Hidden Hills Solar Electric Generating System (HHSEGS)

(11-AFC-2)

**Data Response, Set 1A
(Response to Data Requests 1 through 50)**

Submitted to the
California Energy Commission

FIGURE 2.2-2aR1
Solar Plant 2, Elevation
 Hidden Hills Solar Electric Generating System

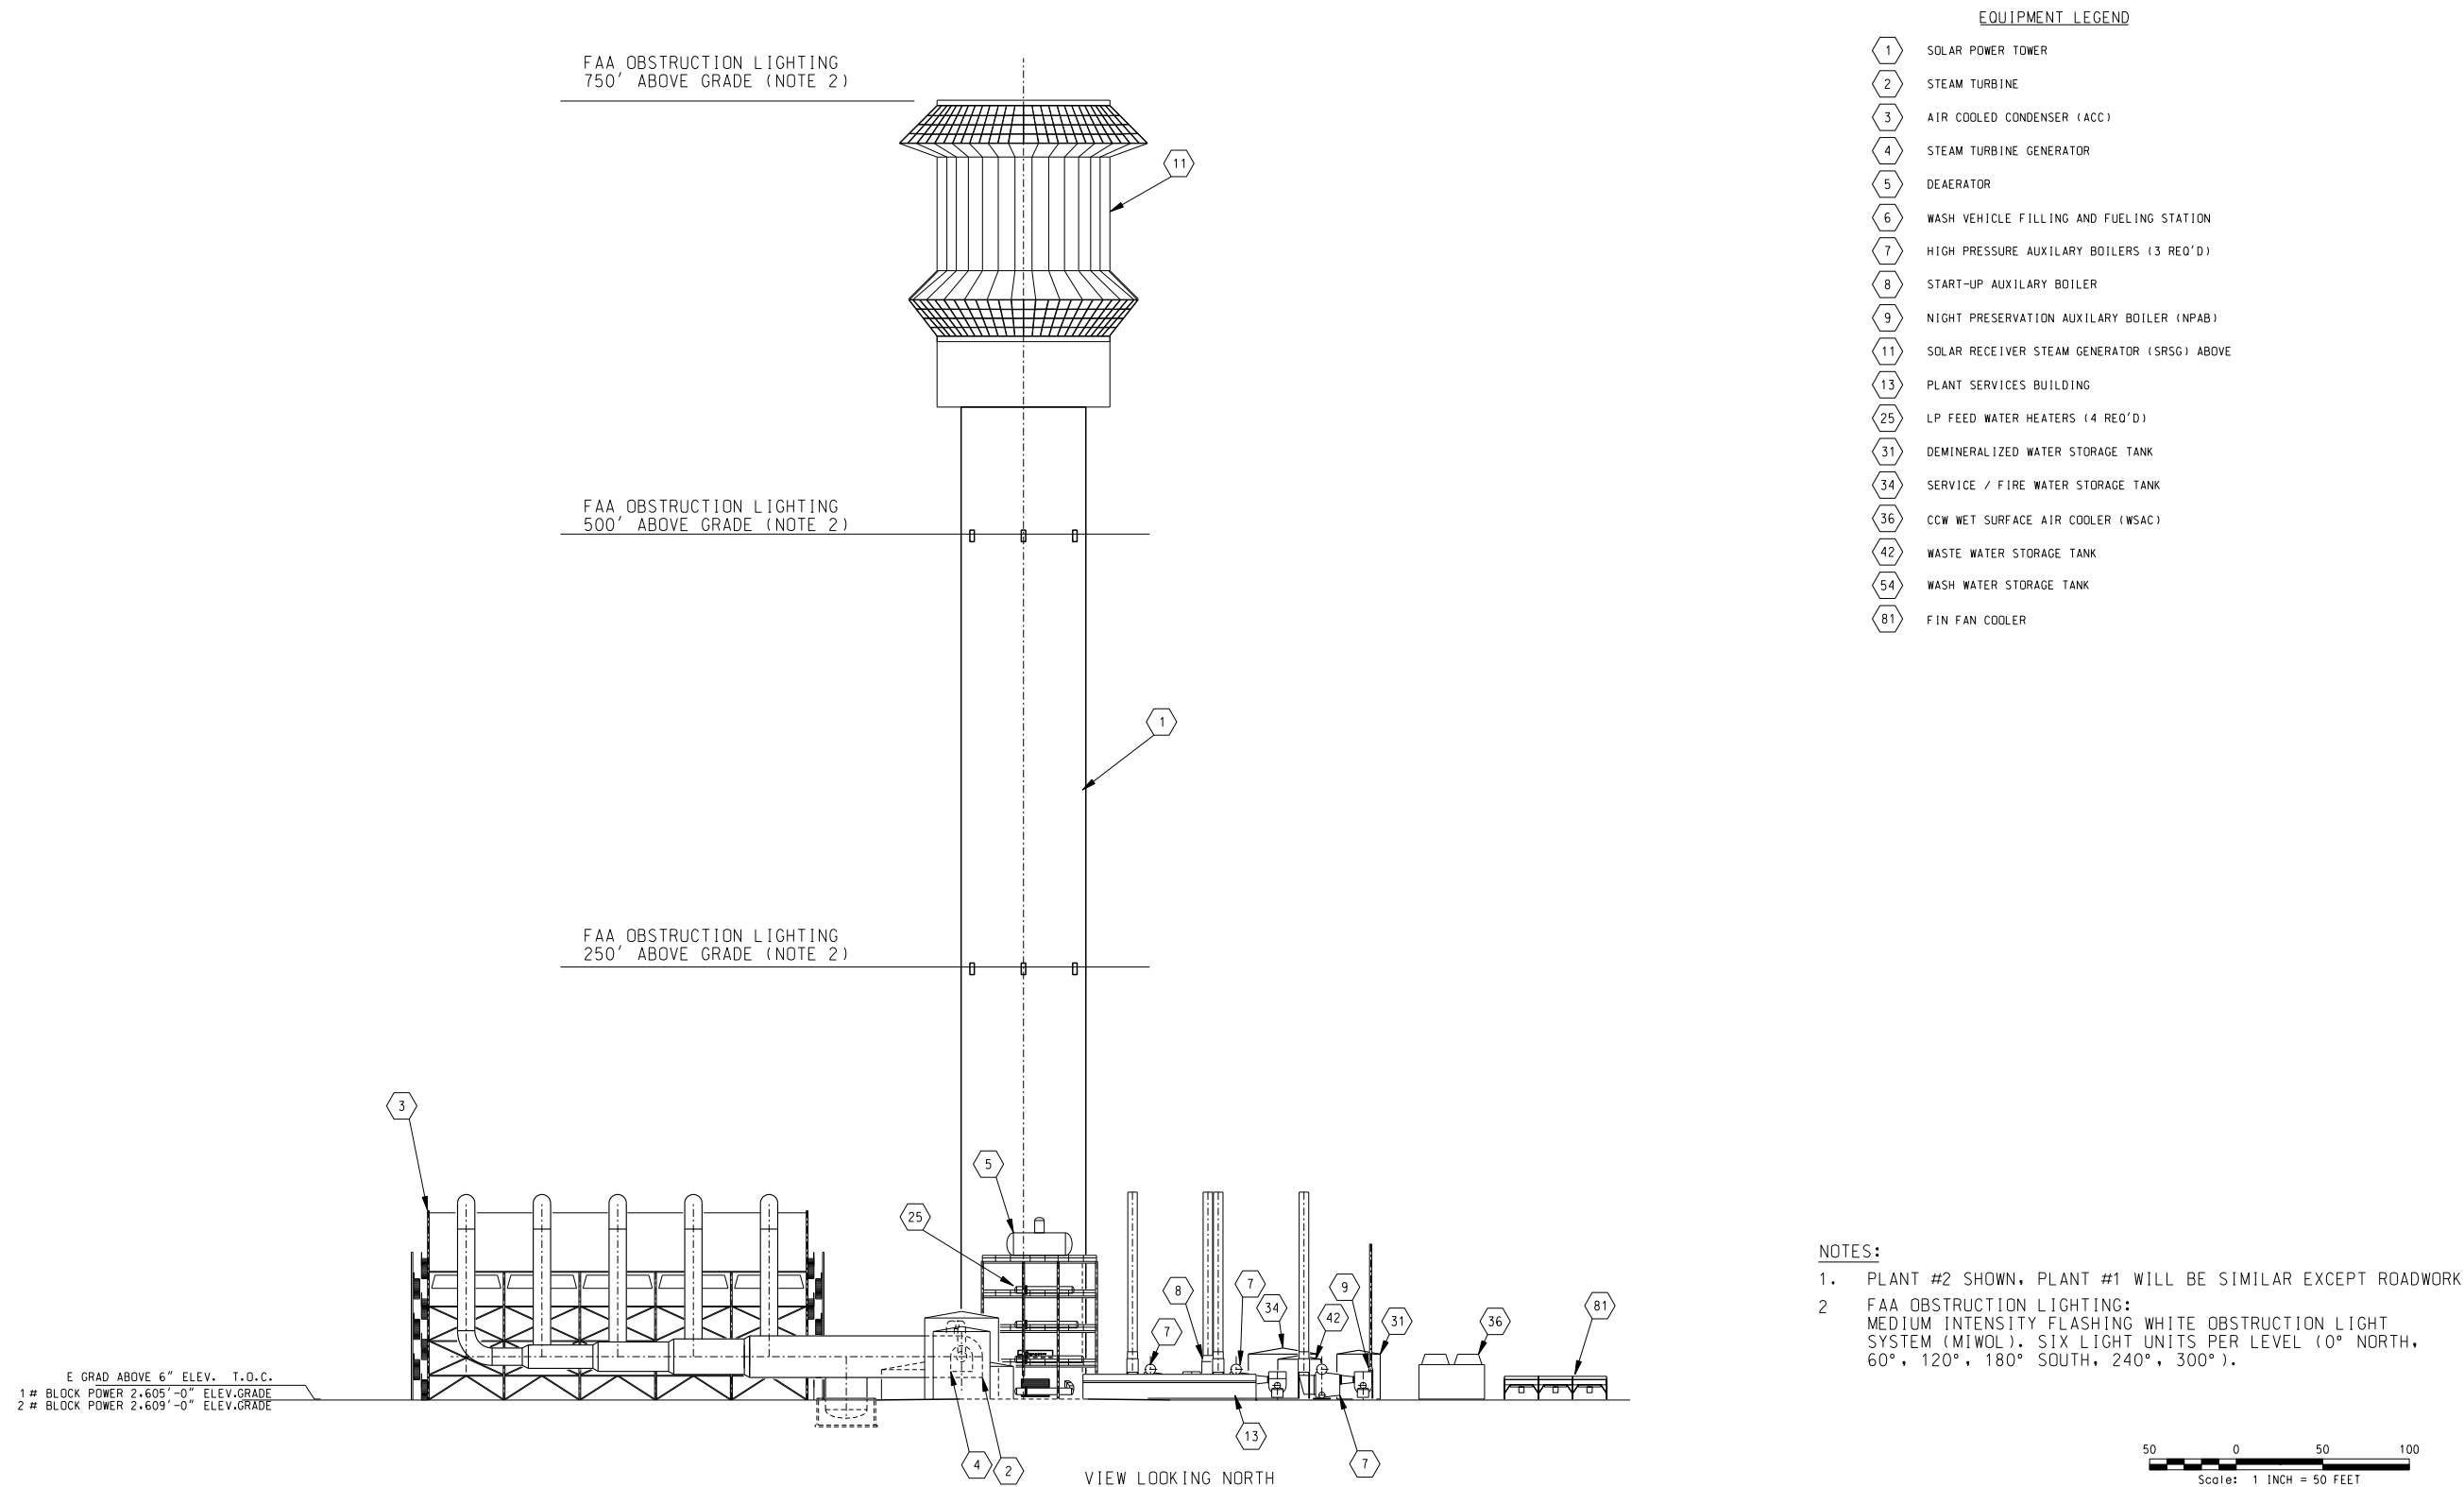
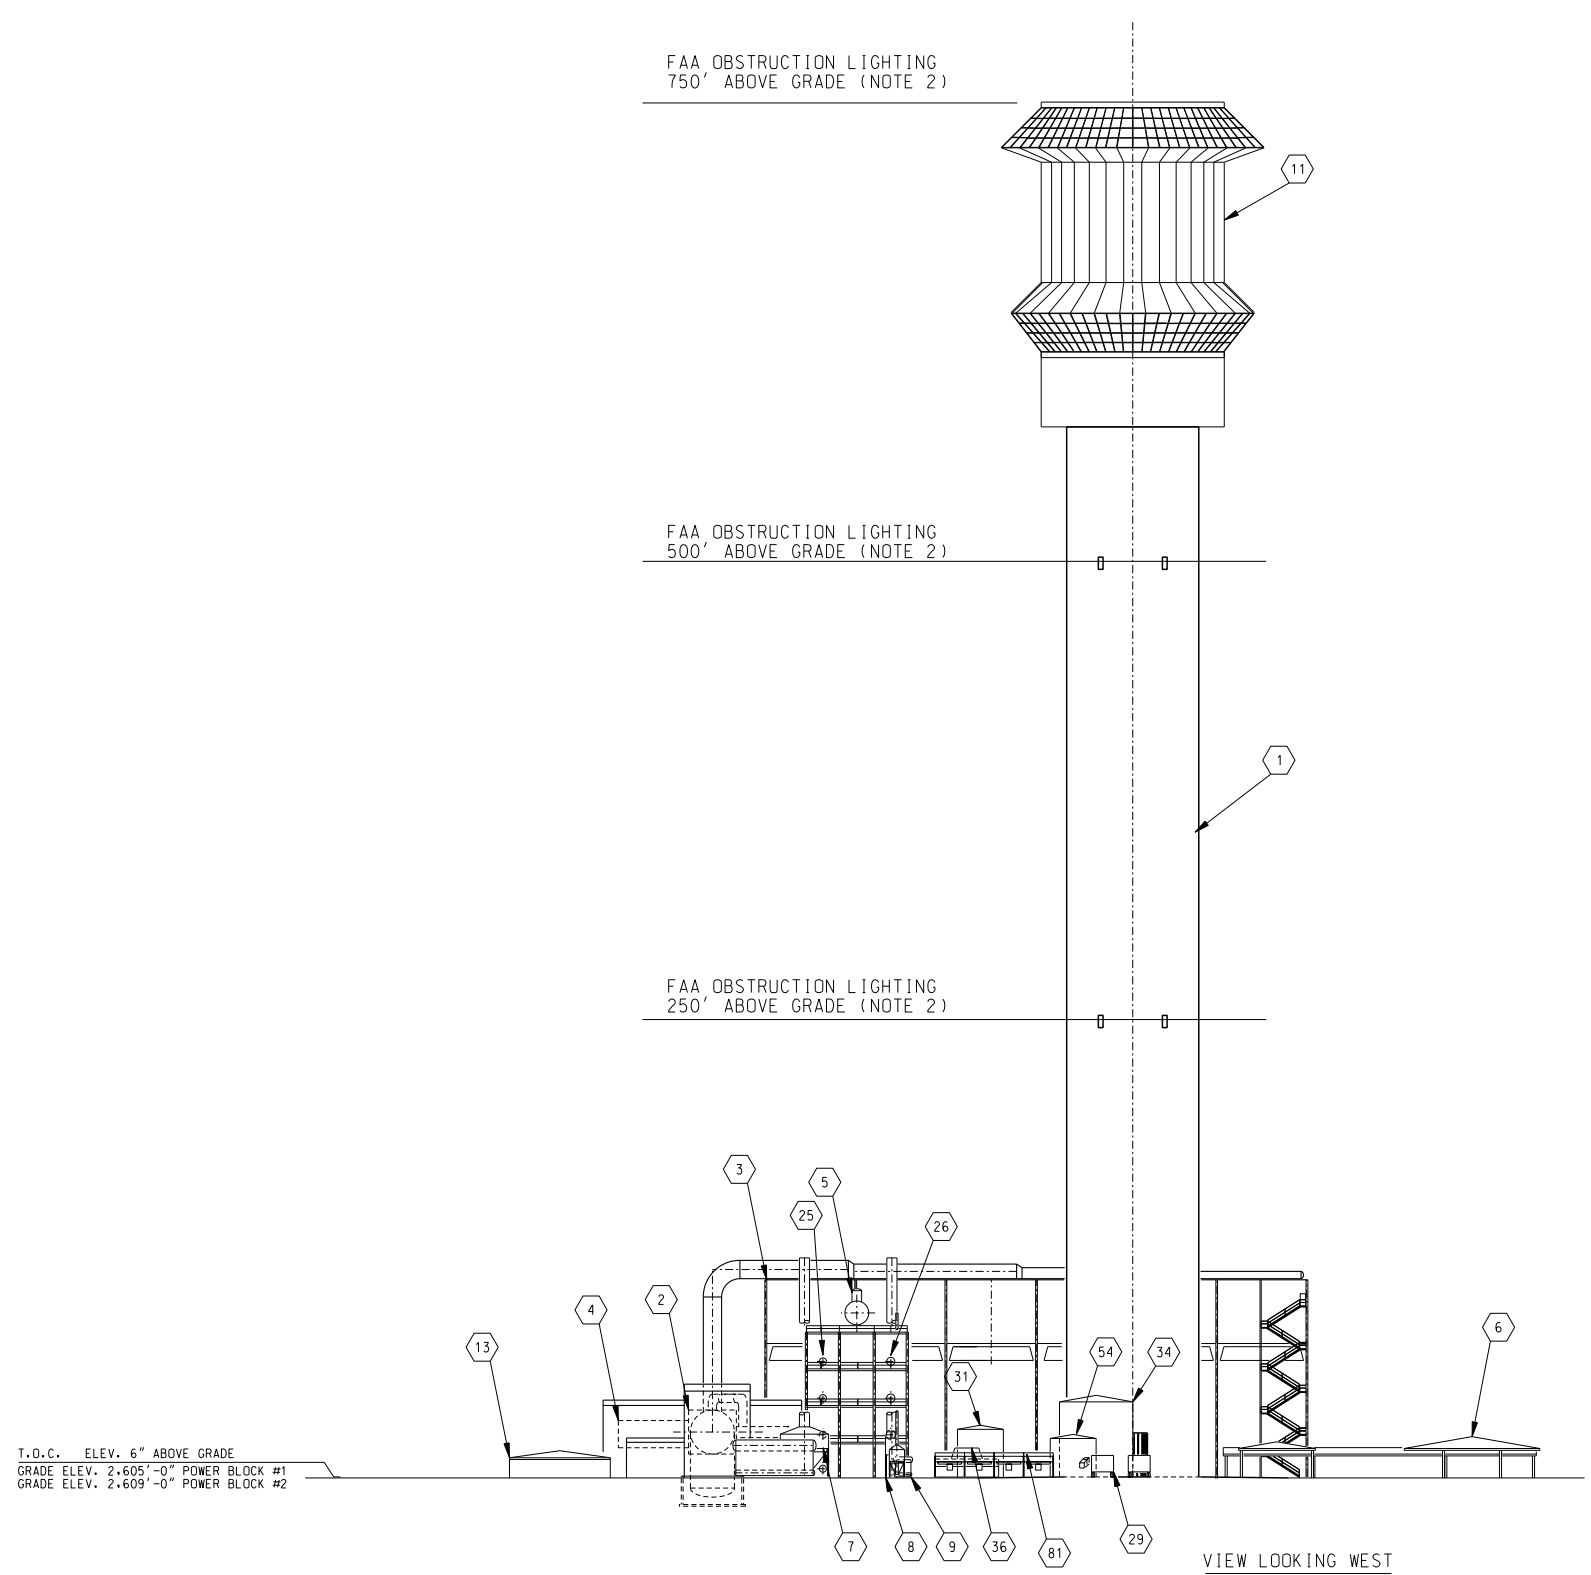
31. Please provide revised Figures 2.2-2a and 2.2-2b-Solar Plant 2, Elevation or a new figure showing the elevations at which the aviation safety lighting will be installed and a symbol for the lights in the legend. Indicate how this meets FAA regulations.

Response: Figures 2.2-2a and 2.2-2b-Solar Plant 2 have been revised to show the aviation safety lighting. Copies of the revised figure 2.2-2a-R1 and 2.2-2b-R1 are attached.

Figure DR34-1
Approximate Transmission Pole Placement
Hidden Hills Solar Electric Generating System

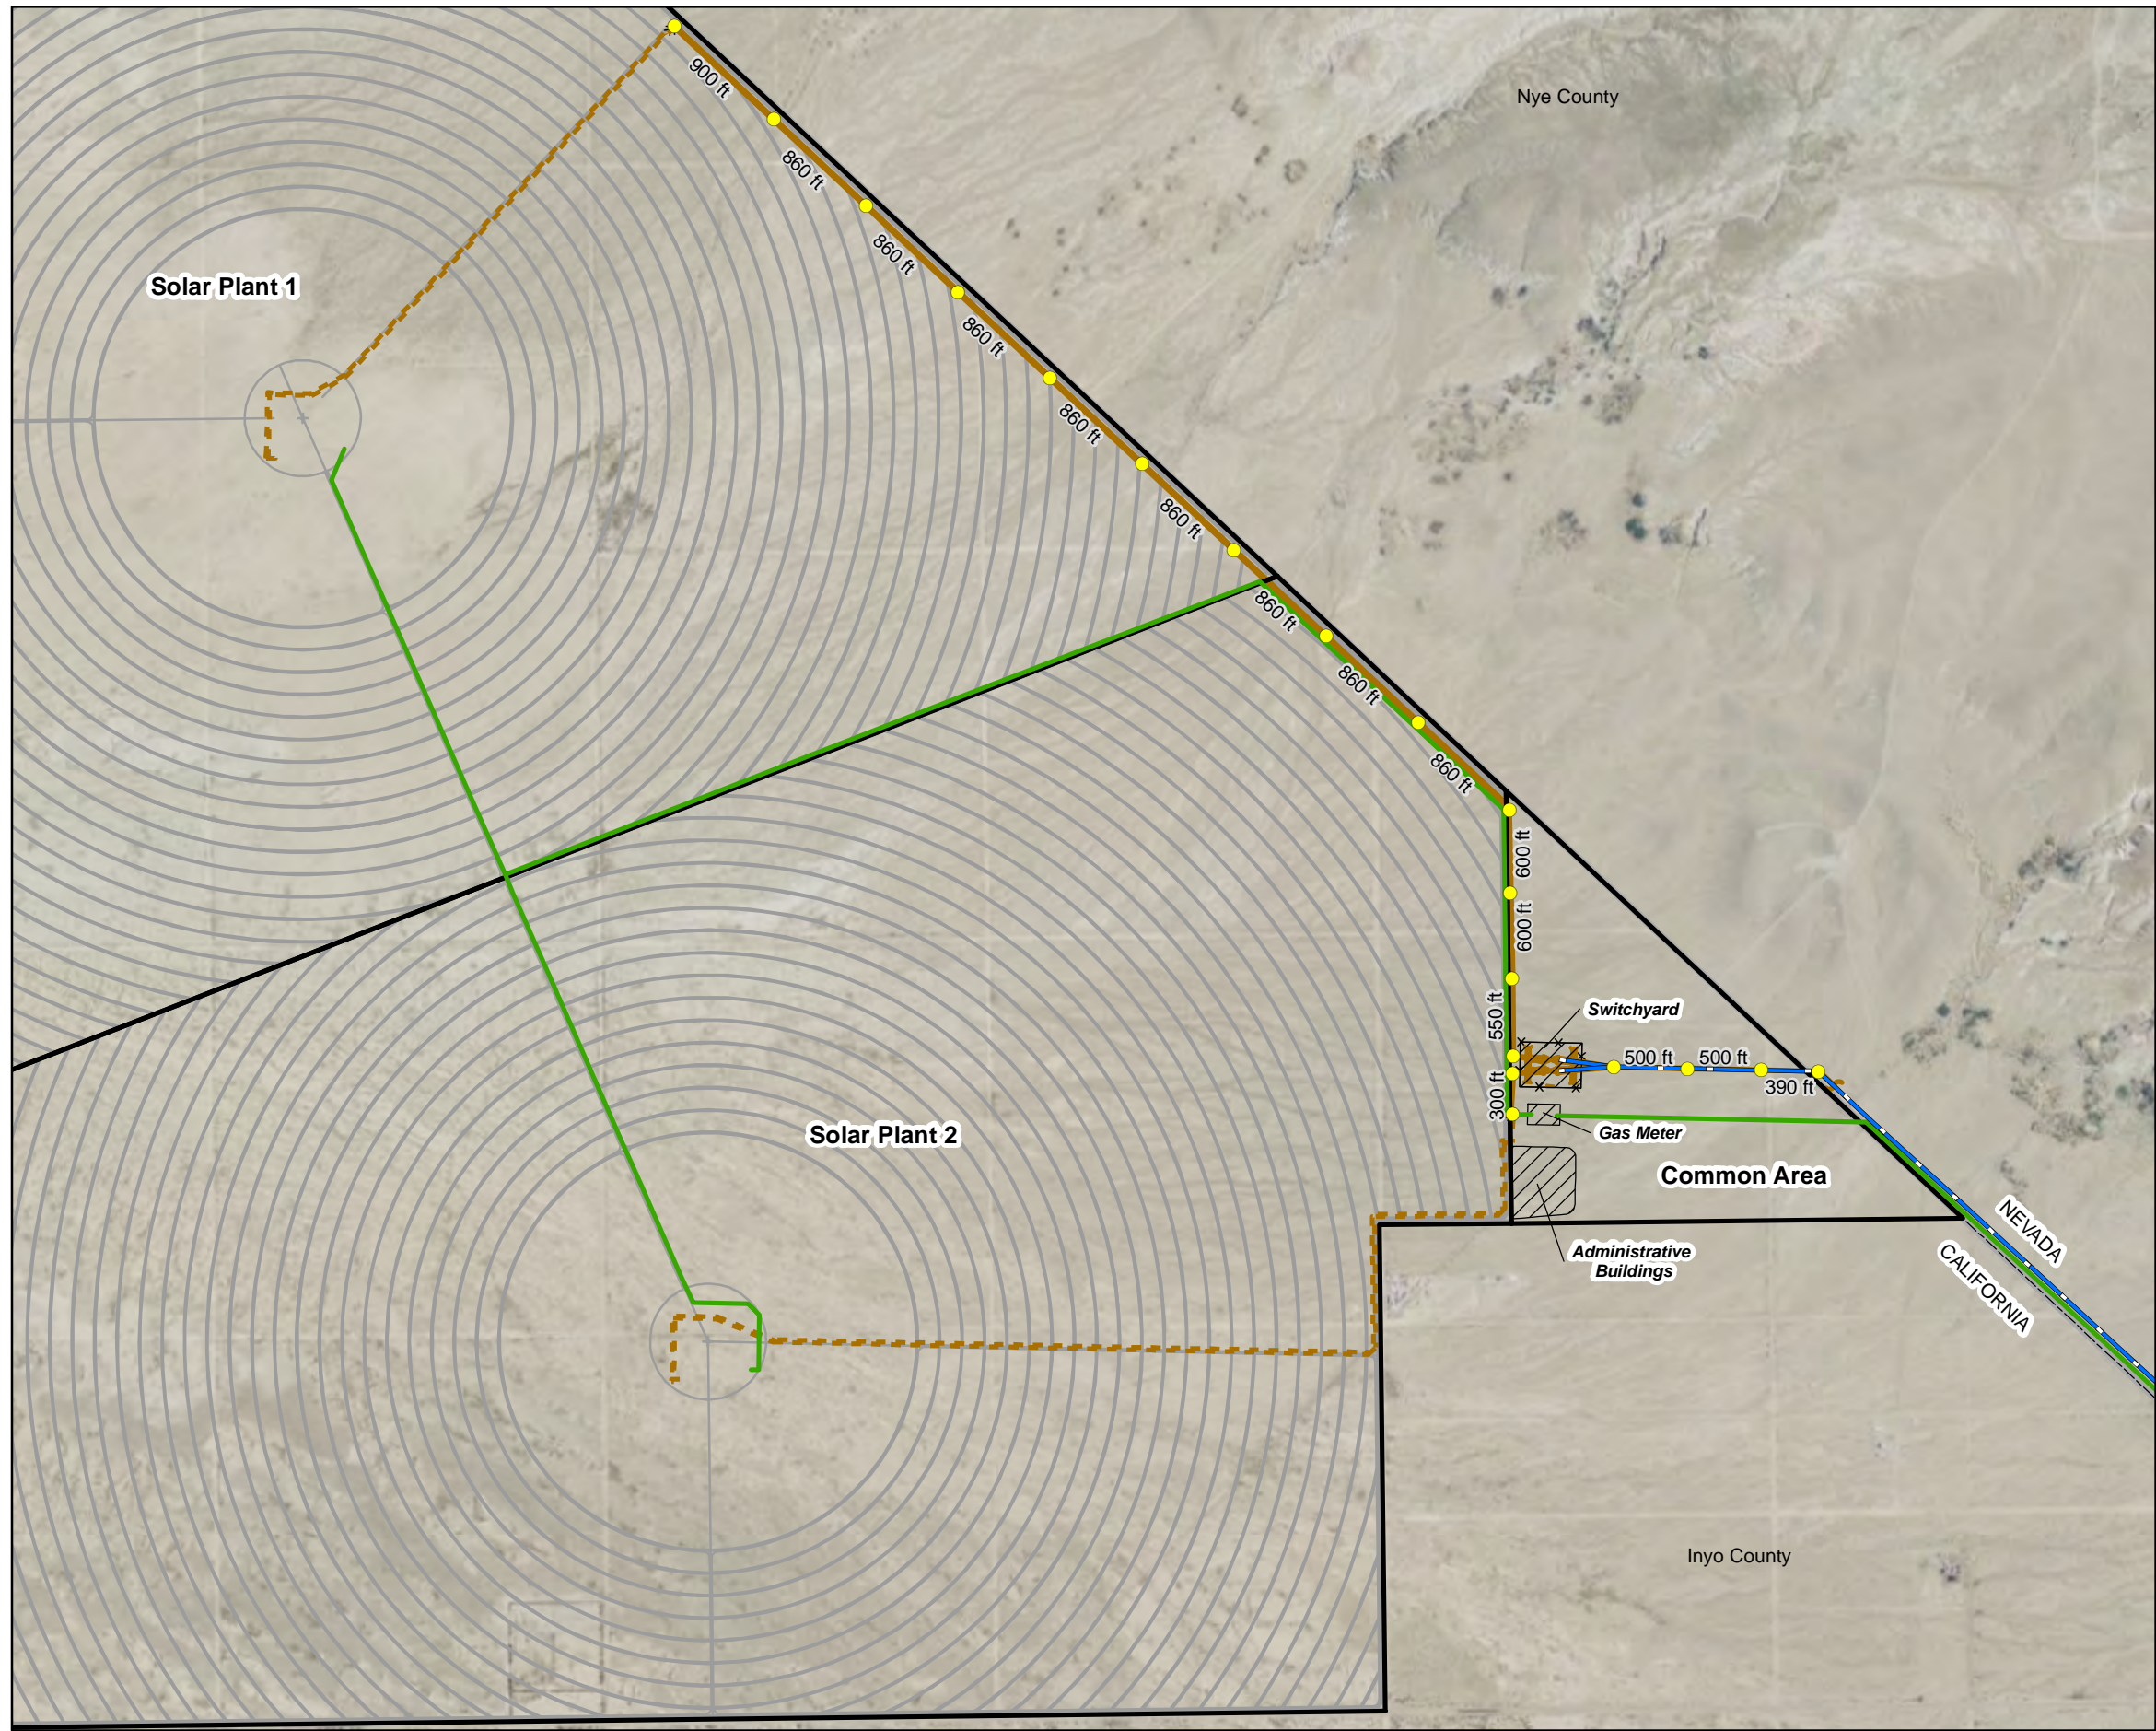
34. Please update Figure 3.2-1 or provide a new figure showing the location(s) of the proposed onsite transmission poles and indicate approximate spacing in feet. (This information is required by other technical disciplines, including Biological Resources, Cultural Resources, Transmission System Engineering and Visual Resources).

Response: Please see new Figure DR34-1, Approximate Transmission Pole Placement. The project's switchyard and gas metering station, as shown in this figure, have been relocated south of the location submitted in the AFC, to be more central. At this location, the number of onsite transmission poles is increased by 2 additional poles, to a total of 18. Their approximate spacing is shown in the figure and ranges between 300 feet and 900 feet. Relocating the switchyard and gas metering station to the south results in a slight change to the onsite construction duration. The change is too small to affect the workforce loading provided in AFC Table 5.10-16, Construction Personnel by Month (which was expanded in response to Data Request 24). Therefore, no change in peak annual air pollutant emissions is expected. Maximum daily NO_x and PM₁₀ construction equipment emissions for the project are expected to occur in late summer/early fall of 2013 (July through October; see Table 5.1F-1 and Attachment 5.1F-1 of the AFC). The minor additional construction that would result from the relocation of these facilities is expected to occur in the winter of 2013, and therefore, is not expected be concurrent with the peak construction emissions months already evaluated. The air quality impacts of construction as addressed in the air quality section of the AFC are therefore not expected to be affected. The relocation has no impact on Biological Resources, since plant avoidance has not been proposed as a viable mitigation measure for this project. In addition, the relocation has a benefit related to Cultural Resources by avoiding certain features described in the materials that must be filed with a request for confidentiality. The relocation has no affect on the other environmental disciplines addressed in the AFC.

Response: As Figure DR34-1 indicates, the power generated by Solar Plants 1 and 2 will be conveyed from the Solar Plants through the areas devoted to the heliostat arrays by means of underground transmission lines. The underground line from Solar Plant 1 will transition to overhead at the eastern edge of the Solar Plant 1 heliostat array, and from there, will continue overhead along the eastern edges of the Solar Plant 1 and 2 heliostat arrays until reaching the switchyard. The transmission line from Solar Plant 2 will be nearly entirely

underground, with its only overhead segment consisting of a 300-foot span located between the terminus of the underground line and the connection to the proposed switchyard. Based on a close review of Figure DR34-1 and the current simulated view from KOP-3, it was determined that the point at which the transmission lines from both power block units transition from underground to aboveground would be outside the view of KOP-3. This determination was confirmed through preparation of a GIS plot of the solar plant and transmission line facilities on which the view cone seen from KOP-3 was superimposed. Because the aboveground portions of the transmission lines will not be visible in the view from KOP-3, there is no need to revise the simulation of the KOP-3 view to add overhead transmission lines.
